Responses to CEC Data Requests Set Three (45-Day Extension)

Amended Application for Certification
for
HYDROGEN ENERGY CALIFORNIA
(08-AFC-8A)
Kern County, California

**RESPONSES TO DATA REQUESTS (45-Day Extension)
FROM CALIFORNIA ENERGY COMMISSION (CEC)**

Photograph 1: View of the California Aqueduct at Tupman Road (see Point 1 on sketch map), camera facing west.

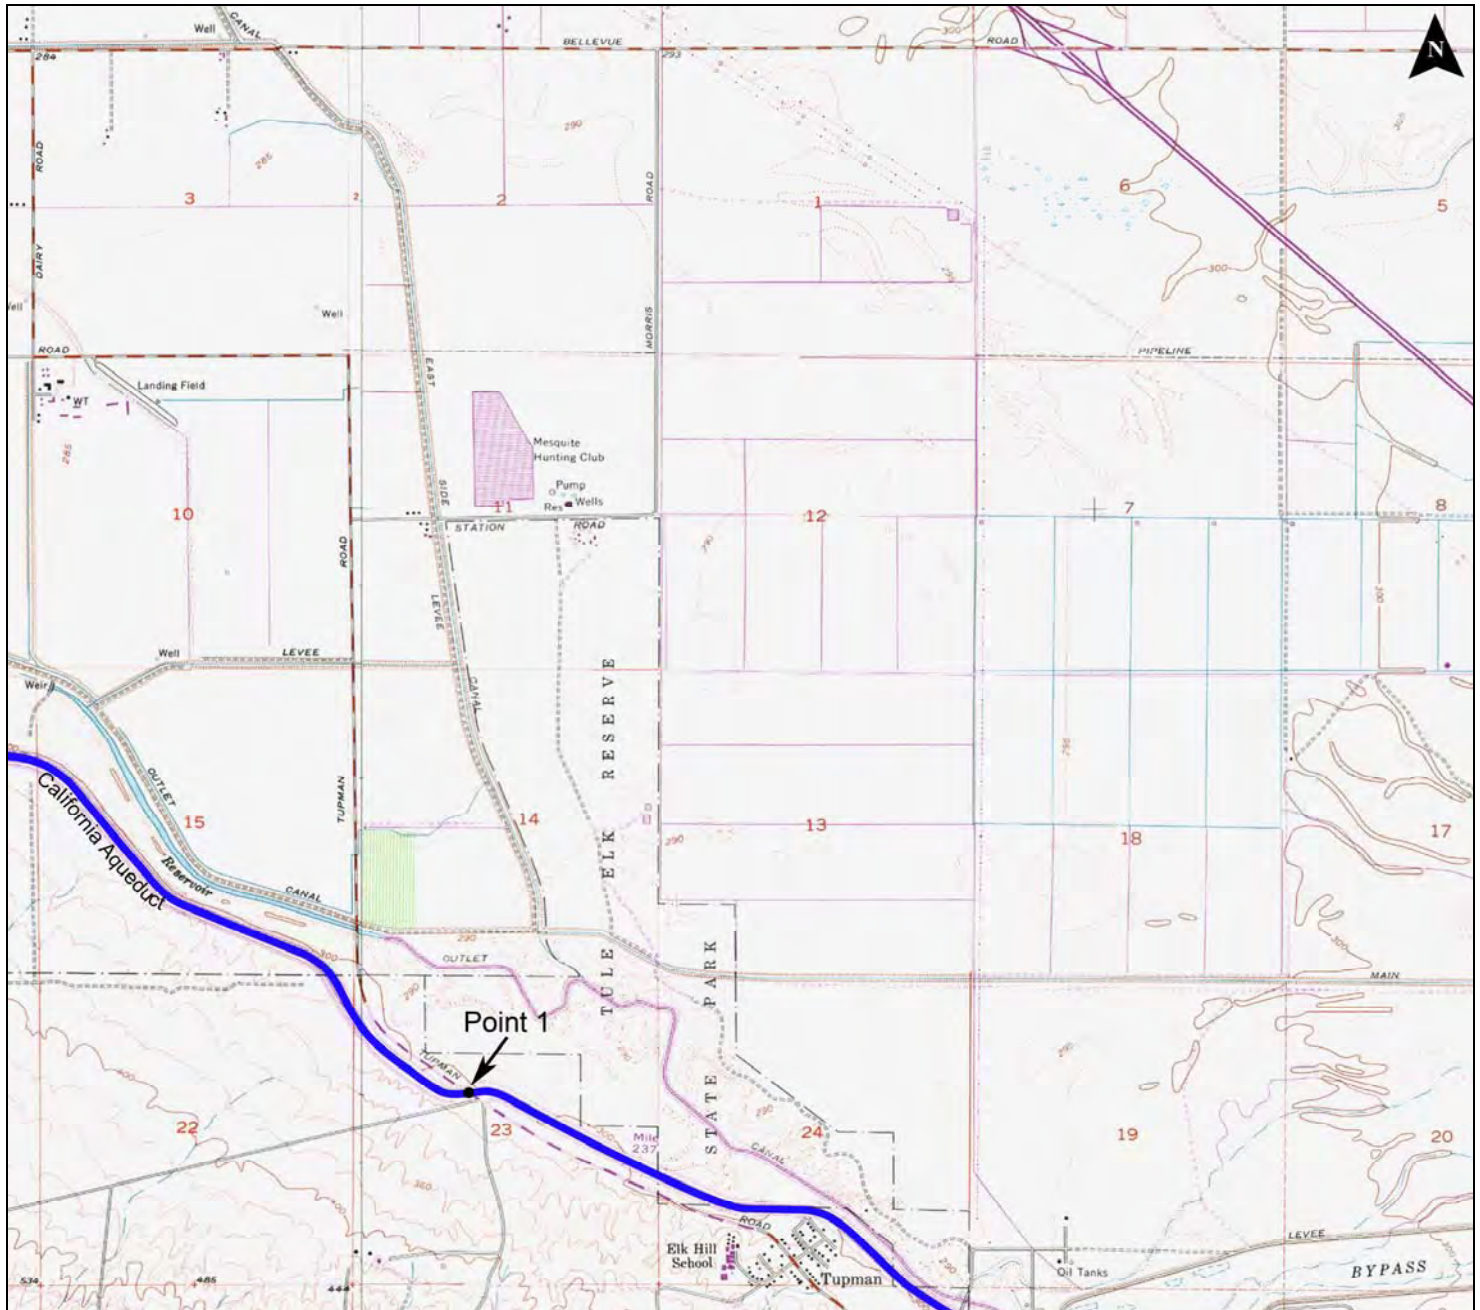
- a. The location of photograph (dated 7/26/06) provided on the DPR 523 form map on page 2 of 4, appears to be taken in the vicinity of the Delta Mendota Canal in Tracy, CA, nearly 200 miles north of the project. As the photo location is outside the current PAA, provide a current photo of the portion of the aqueduct within the PAA and a map identifying its location. Staff suggests a photo location of the aqueduct near the Old Headquarters Weir.**

A DPR 523 form update sheet for Map Reference No. 11 (California Aqueduct) has been provided, which includes a current photograph and site map of the aqueduct at Tupman Road (outside the current PAA), as agreed to by the CEC in a teleconference on December 3, 2012. This new update sheet, and the original 2007 DPR form, are included as Attachment A184-1.

FIGURE A210-1

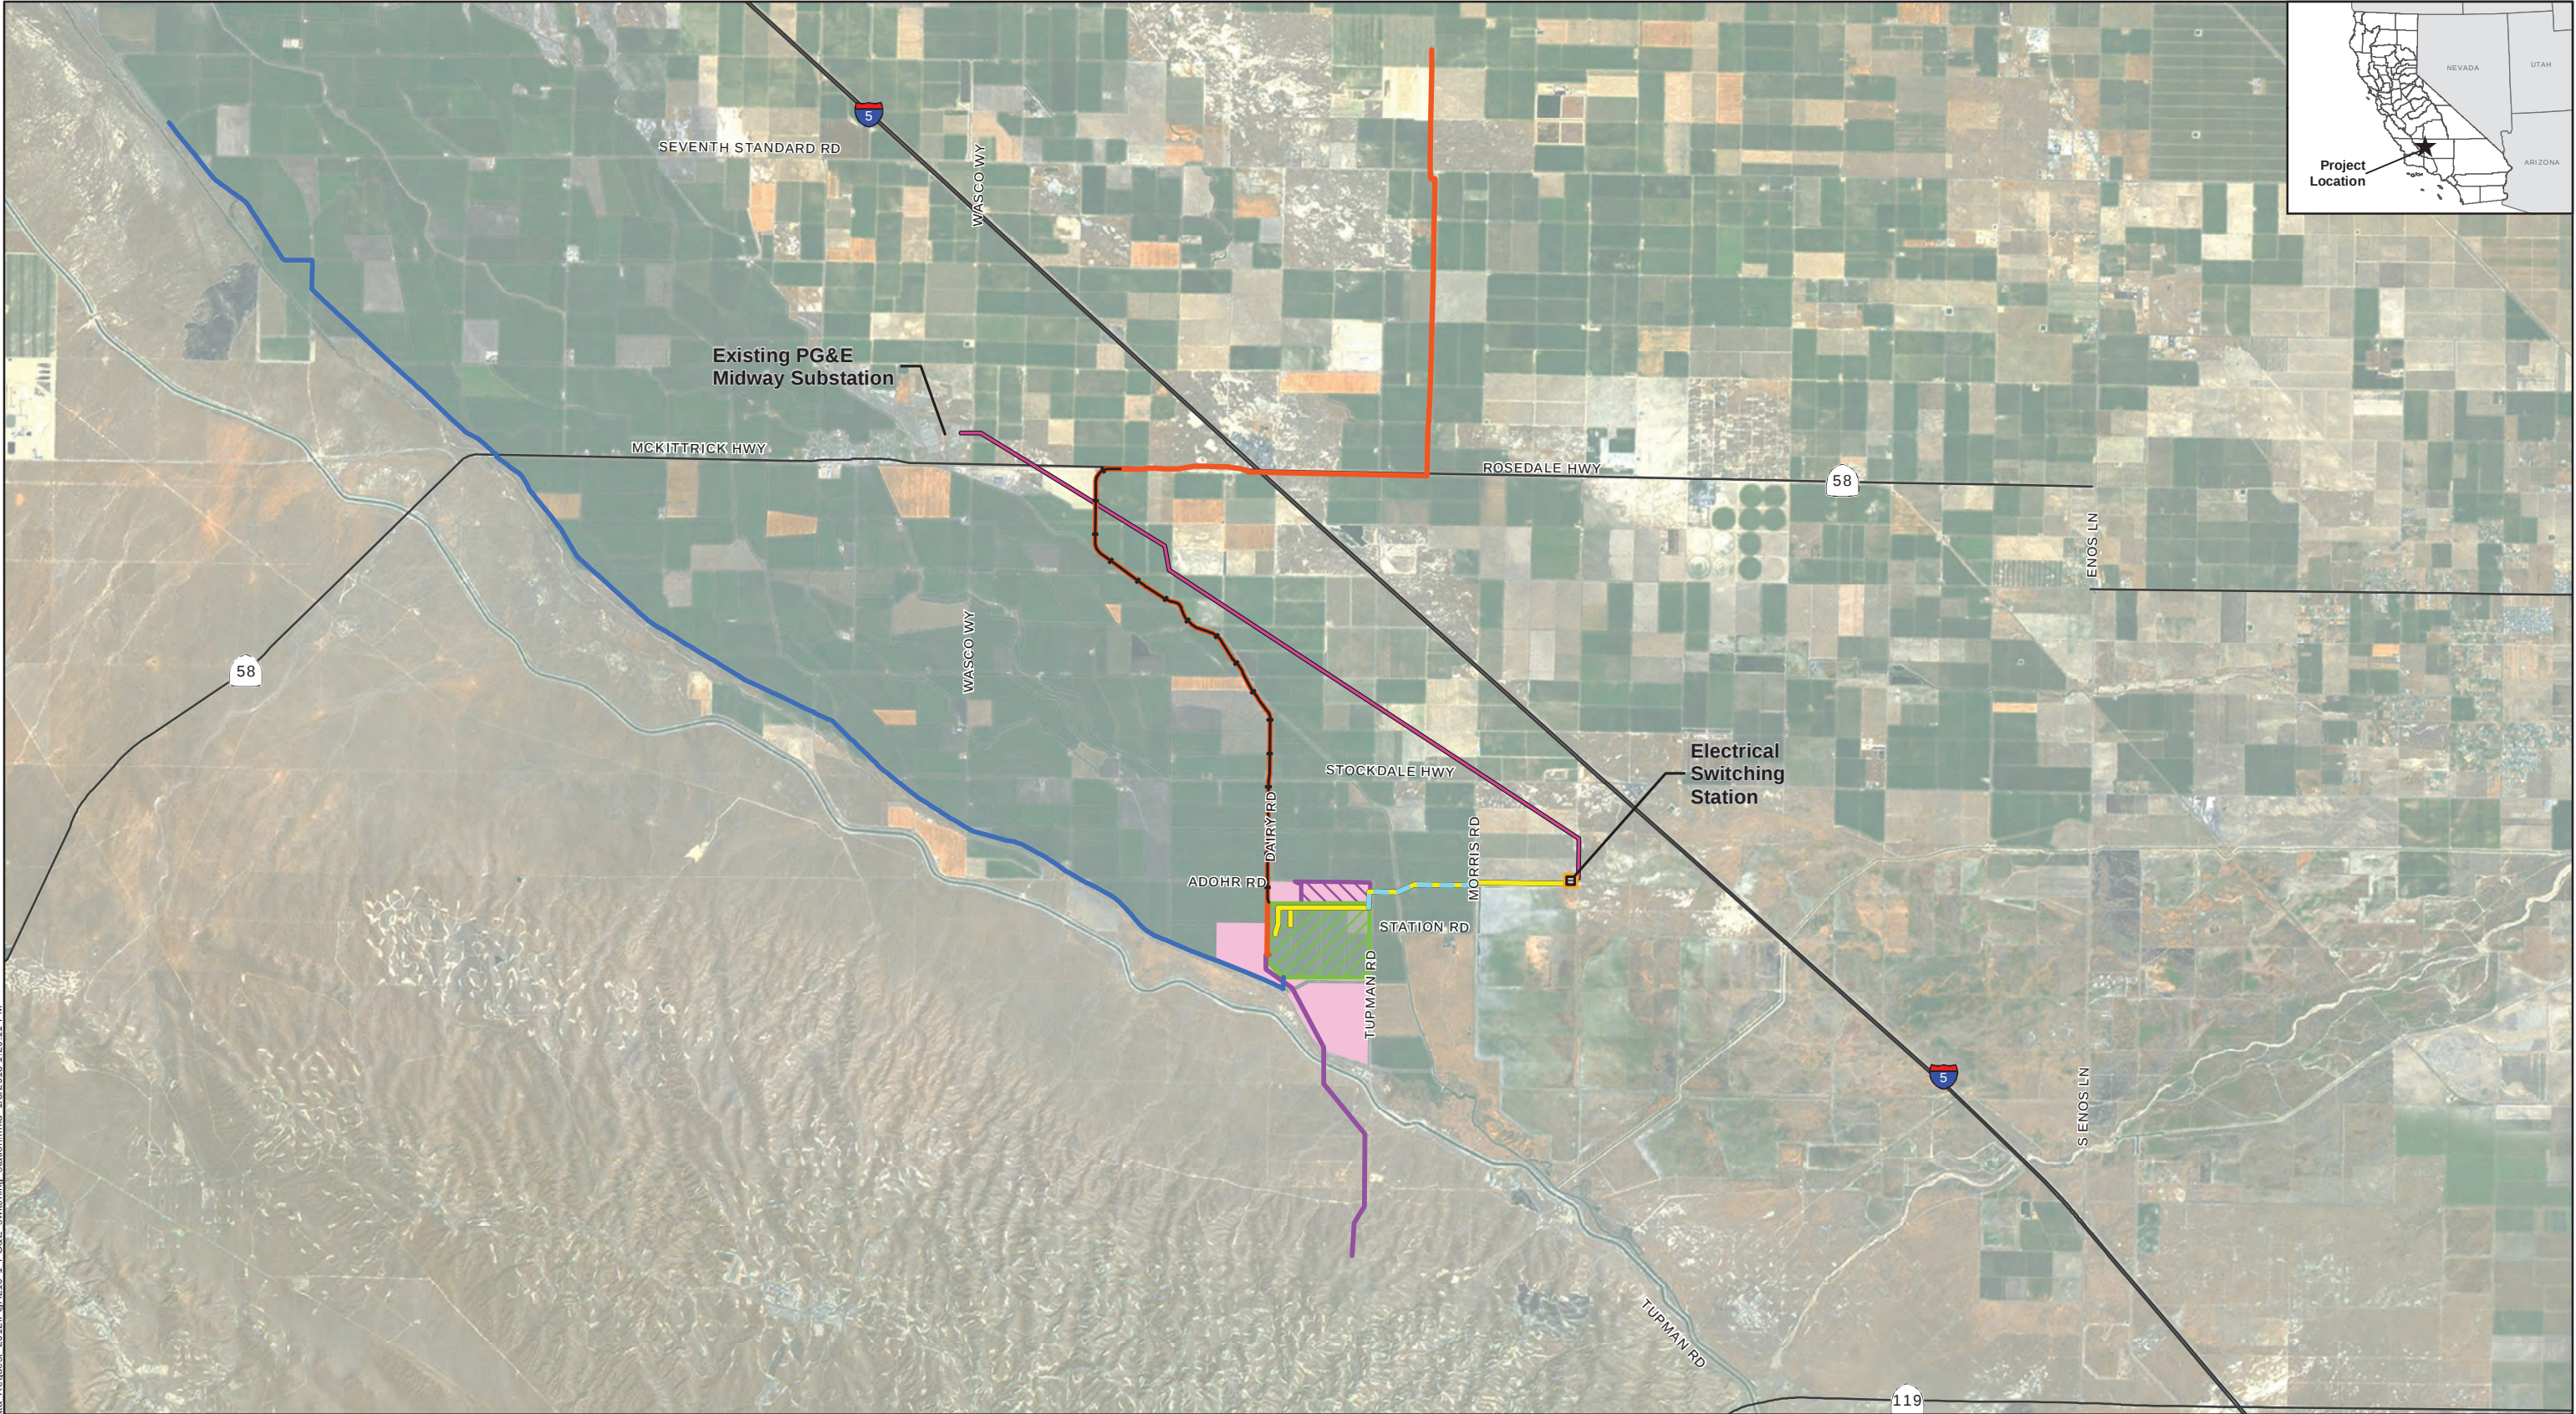
A210. Please provide a map to scale and written description of the location of the proposed PG&E switching station and also provide the Assessor's Parcel Number.

The proposed Pacific Gas and Electric Company (PG&E) switching station will be located approximately 2 miles east of the HECA Project Site at the intersection of an unimproved farm road and Elk Valley Road as shown on Figure A210-1. The switching station is located within Assessor's Parcel Number 159-010-06, in unincorporated Kern County, California. The 4-acre switching station site is located on land currently used to grow alfalfa. Additional information about the switching station is provided in Appendix A.
